I object to the Beaches Link as presented in the EIS due to the following:

BL EIS Appendix F, Annexure B (Figure 1) shows that just 25% of BL traffic is expected to use the western link through Artarmon. The Warringah Freeway-Gore Hill Freeway has the capacity for this traffic.

Figure 2 – The previous plan: completing the North Western Motorway with tunnels and bridges rather than huge cuttings through suburbs (route A in pink and orange). The project is route B in red)

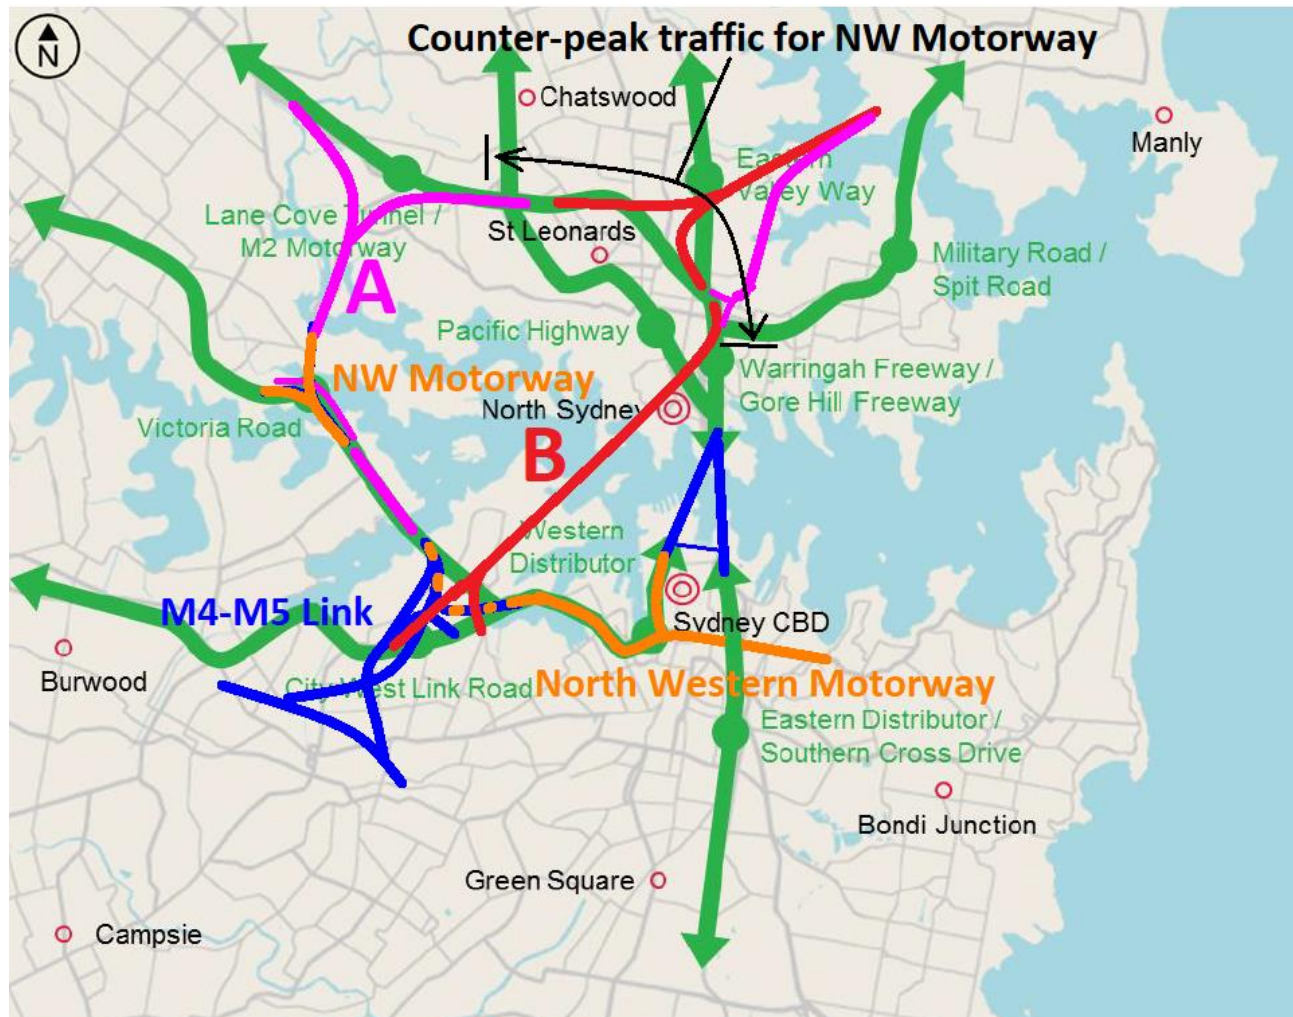
The North-Western Motorway, from the Sydney CBD to the M2, is two-thirds complete missing tunnels under Drummoyne and Lane Cove and bridges across water crossings.

The North Western Motorway allows counter-peak flows between the Pacific Hwy and Falcon St connections. Completing the NWM allows the use of real time information to balance traffic across the harbour/Parramatta River.

The tunnel network under Rozelle had to be doubled to provide the WHT links. The extra work under Rozelle for the WHT is sufficient to complete North Western Motorway.

With a maximum grade of 6%, the Beaches Link can connect at Cammeray and make use of the connectivity of the surface motorway at this point. Figures 3 and 4.

Figure 5 – BL EIS Figure 16-13 extract with major infrastructure added.

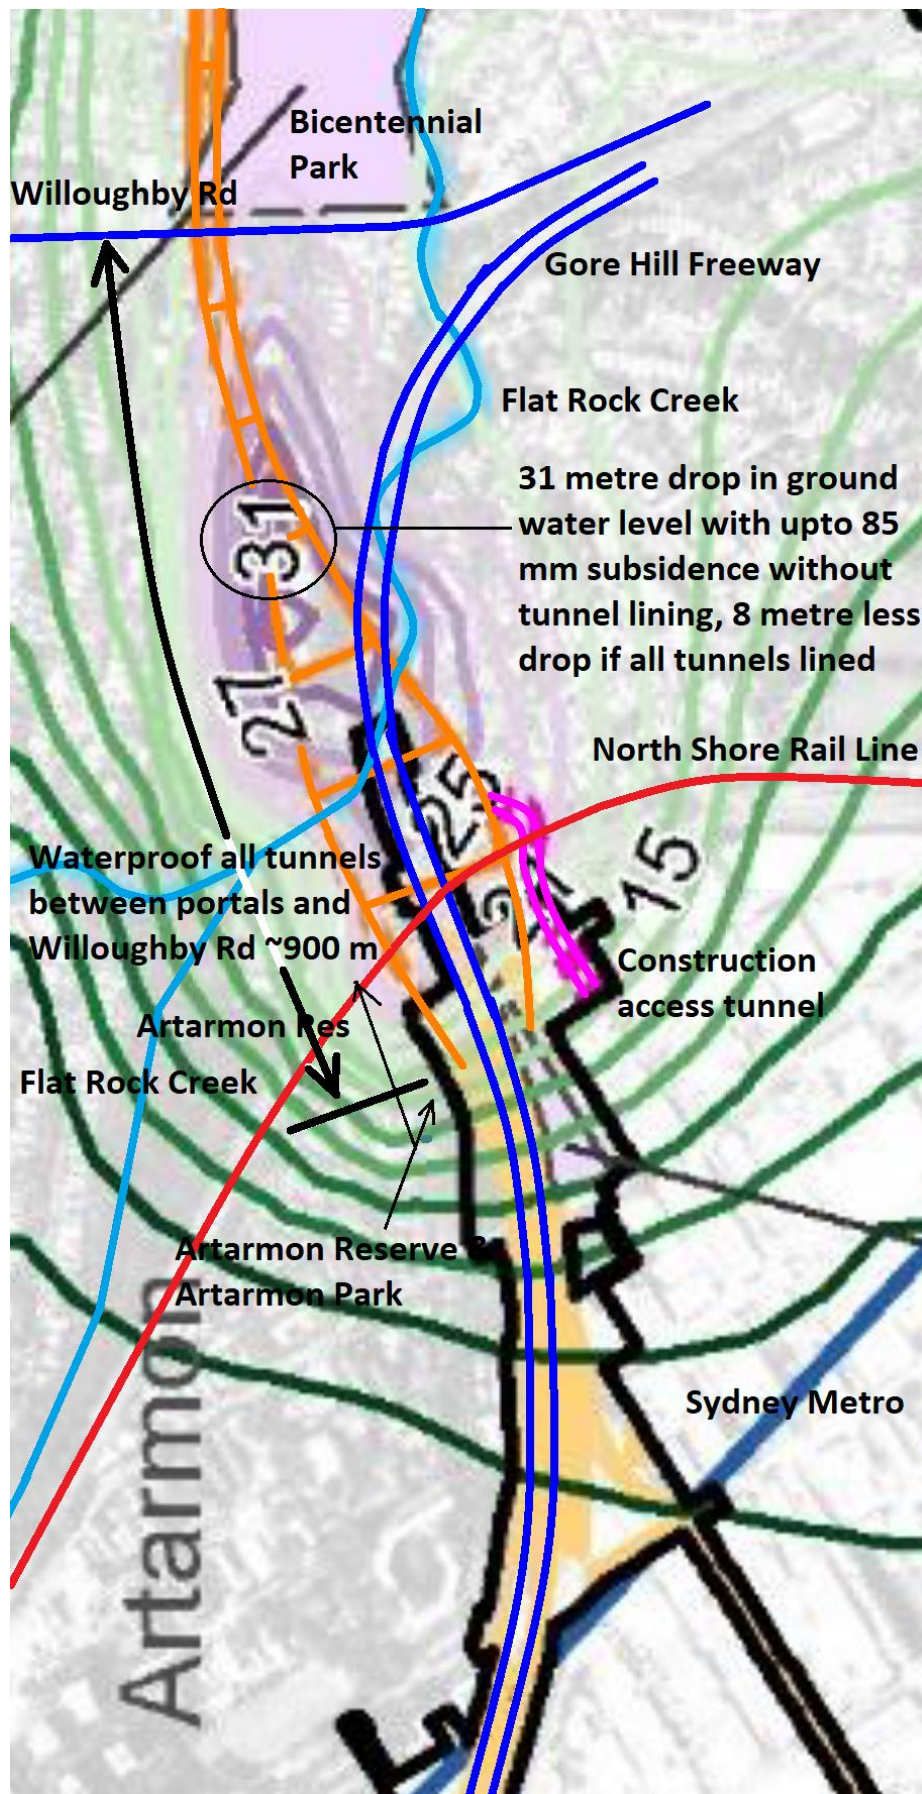
BL EIS Chapter 16 Figure 13 illustrates groundwater draw down in 2128 (submission Figure 5).

At the end of the project (2028) it will be about 8 metres less.

The EIS advises groundwater draw-down would be further reduced by 8 metres if the tunnels are “waterproof” lined.

The EIS proposes the tunnels be lined for 300 metres – essentially to protect the North Shore Rail Line from subsidence.

Given the drawdown extent shown, the ‘waterproof’ lining should be extended for 900 metres (to Willoughby Rd) from the Artarmon portals to protect Artarmon Reserve (and its forest and threatened species) and neighbouring streets from loss of groundwater and subsidence.

**Figure 7 - Sydney Metro City & SW EIS tech paper 1 -traffic and transport Figure 3.8 - Chatswood dive site assessed intersection locations - base and construction level of service**

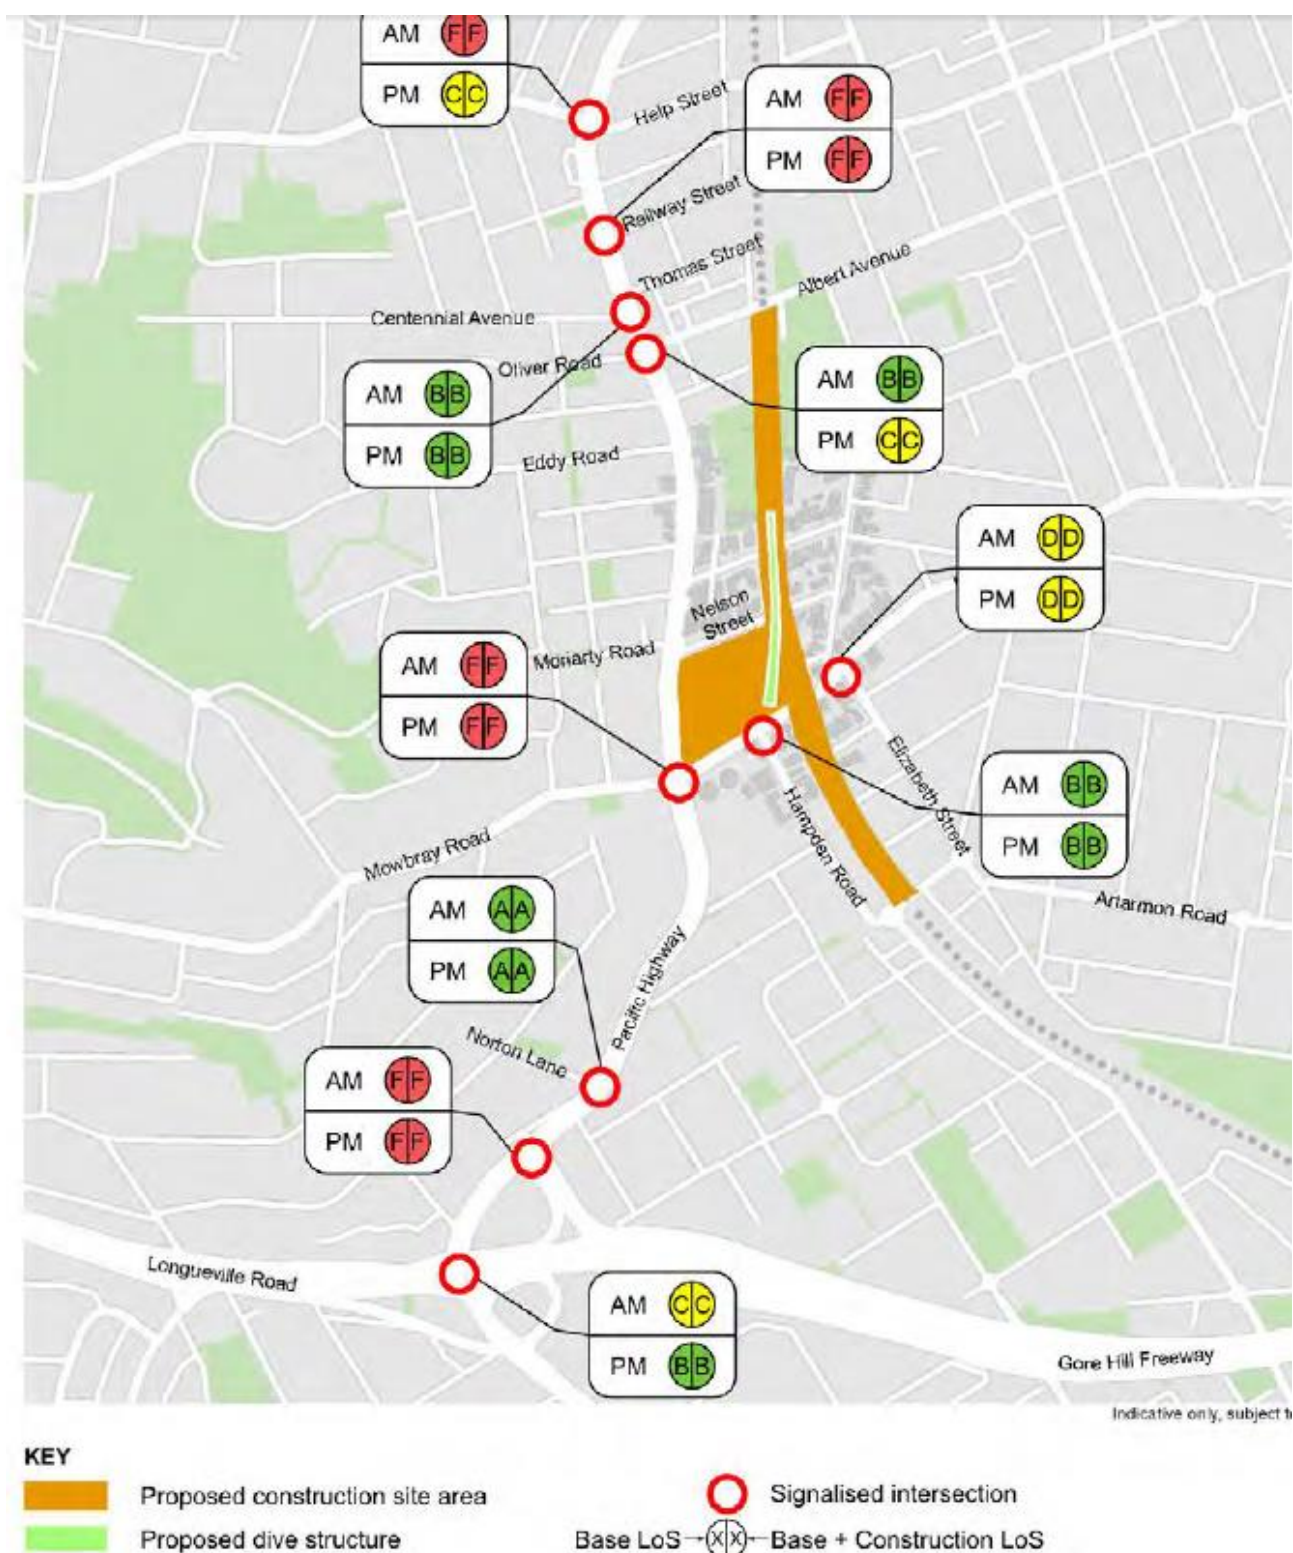
Sydney Metro EIS City & SW EIS tech paper 1 -traffic and transport Figure 3.8 ((Chatswood dive site assessed intersection locations - base and construction level of service)) somewhat disagrees with the BL EIS traffic data (submission Figure 7). However, it indicates traffic improvements are also required on the Pacific Hwy.

The RMS has tried to maintain two-phase signalling along the Pacific Hwy, but often has two 1.5 phase signals at intersections. Three and four phase signals can be fitted in the time given for signal cycles at present – 1.5 to 2.5 minutes depending on time of day and congestion.

The 3 km of Pacific Hwy (A1) from Boundary St to Longueville Rd is a major source of North Shore traffic congestion due to lack of right turn provision to maintain the some-what mythical two-phase regime. The lack of right-turn capacity is as follows:

- Boundary St (A38) – extra right turn lane
- Fullers Rd (A38) – extra right turn lane
- Mowbray Rd – 2 right turn lanes Pacific Hwy southbound (in Sydney Metro EIS and approved by Council); and on right turn lane for Mowbray Rd West to turn onto the Pacific Hwy.
- Gore Hill Freeway ramps (M1, M2) – two right turn lanes for Pacific Hwy northbound to turn onto Gore Hill Freeway and Beaches Link.

**Figure 8 – Diverging diamond intersection with one right turn lane each way**

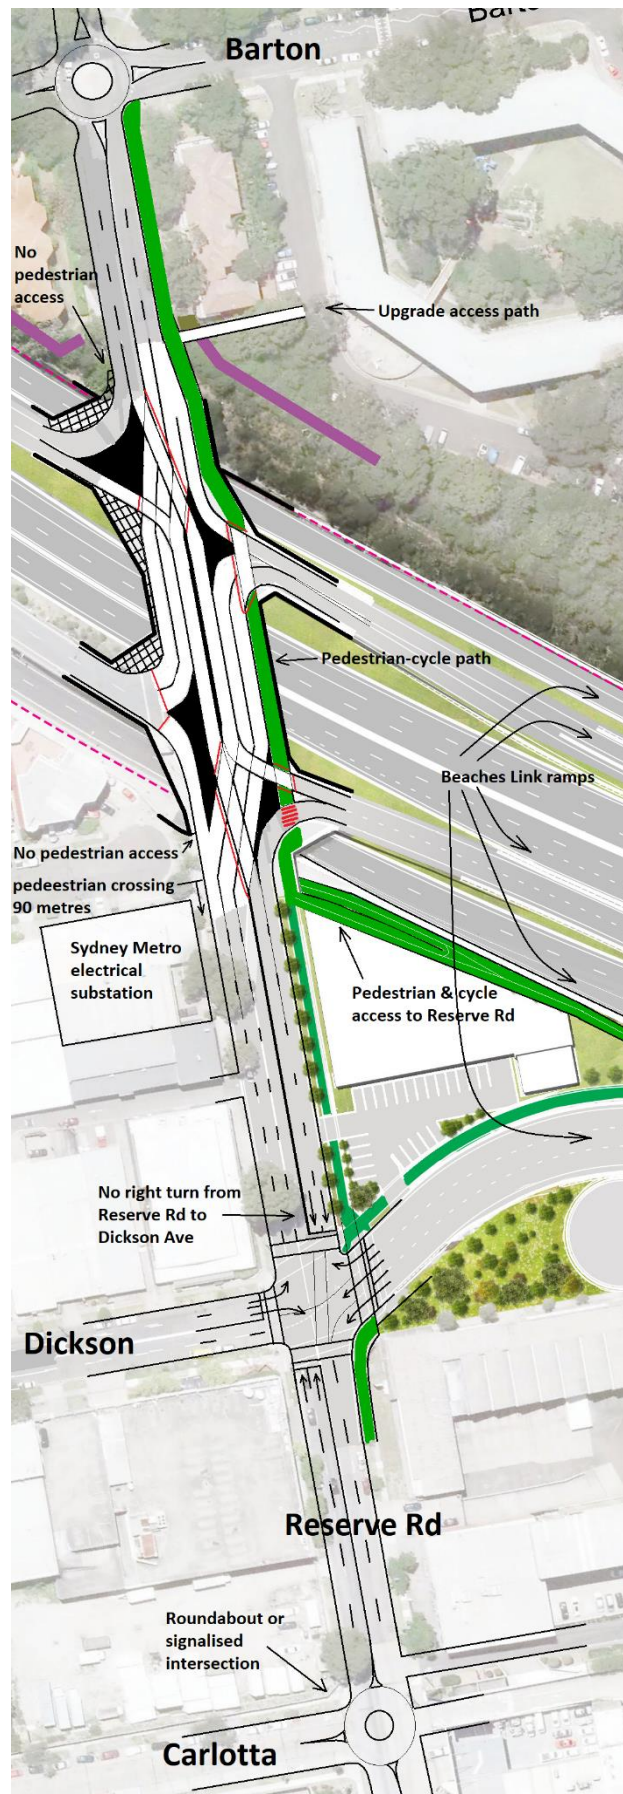
This change could be implemented immediately. Include the changes suggested in Figure 8 at Dickson Ave (right turn ban), Carlotta St (roundabout to ease right turns) and Cleg St (permit left turns)

**Figure 11 – Bifurcate on-ramp from the Pacific Hwy to provide access to both Gore Hill Freeway and Beaches Link**

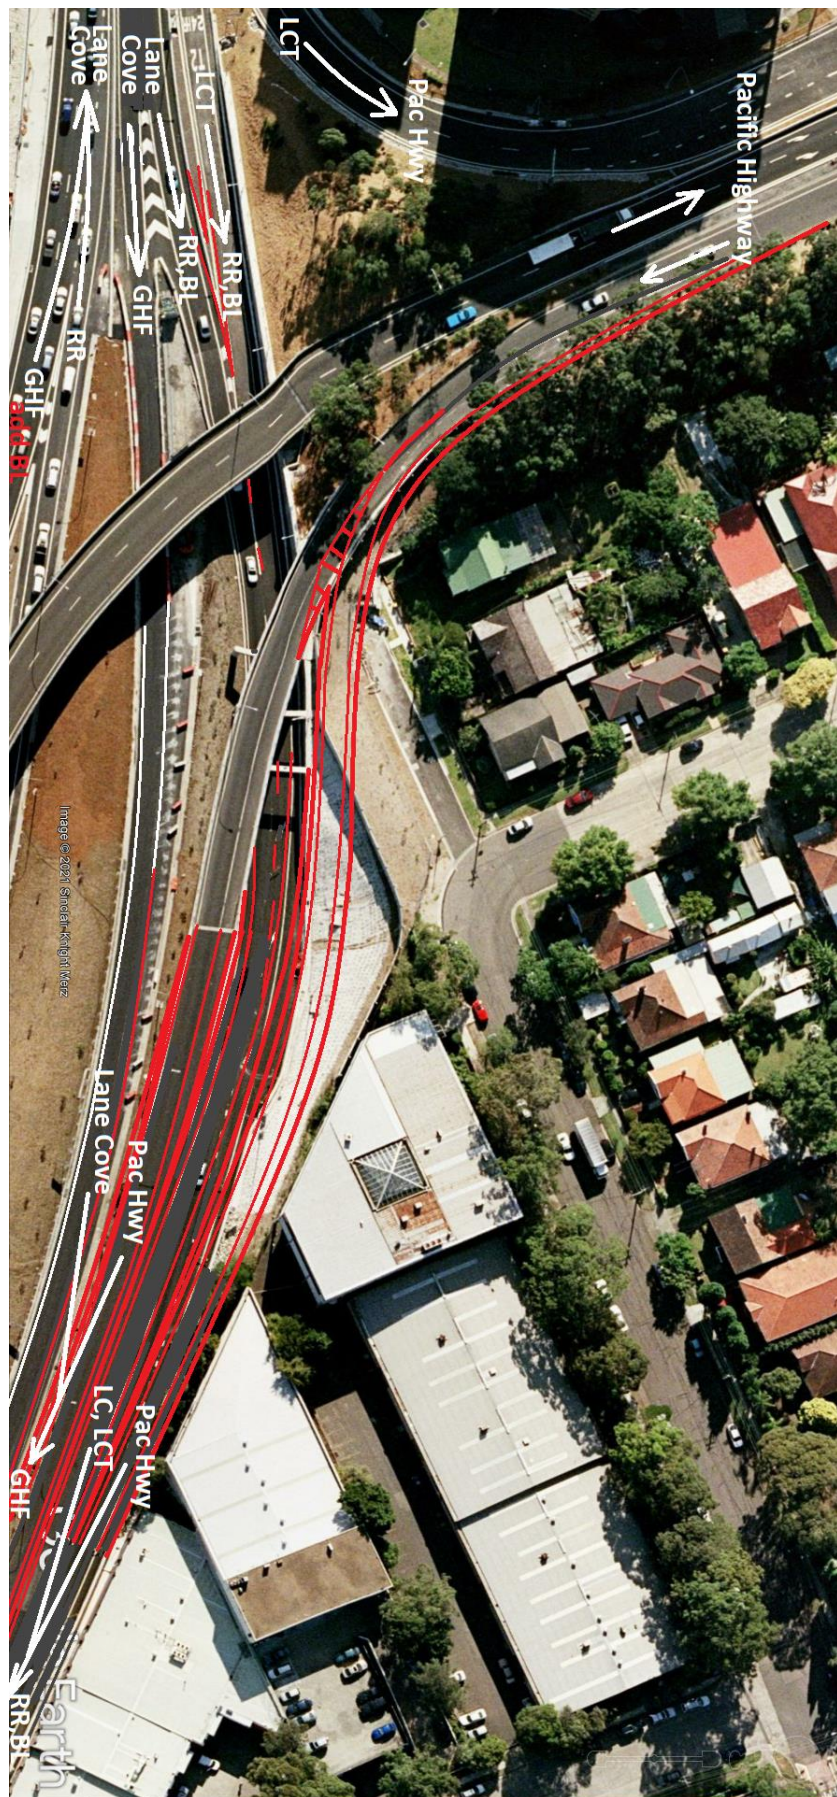
B) Bifurcation of the Pacific Hwy on-ramp to the Gore Hill Freeway to also serve Beaches Link - attached

Figure 12 – Beaches Link southbound exit to Harbour Bridge and North Sydney bifurcated to provide direct link to Harbour Tunnel ramps

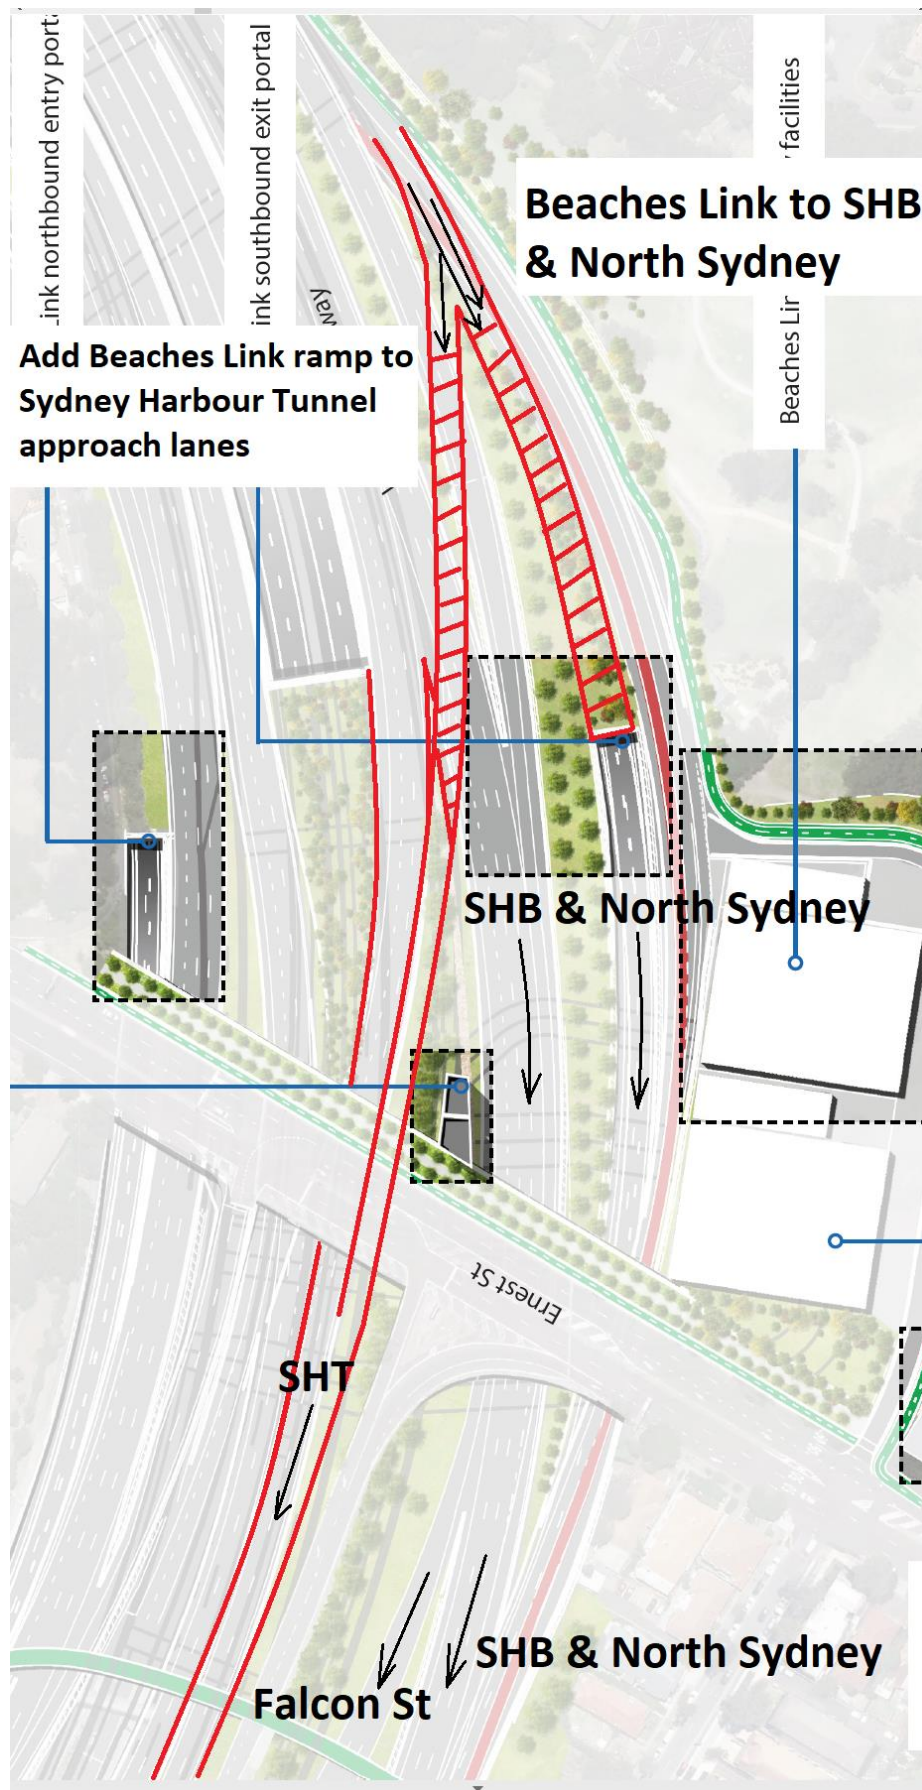
- Beaches Link to and from the Sydney Harbour Tunnel (however, a northbound connection may now be included with RMS's latest go at median strip placement). The Sydney Harbour Bridge must be used and traffic has to mix with Sydney CBD traffic;
- Beaches Link to and from the Pacific Hwy. Dickson and Reserve Roads must be used.
- Beaches Link to Longueville Rd. Dickson Rd and Pacific Hwy must be used.
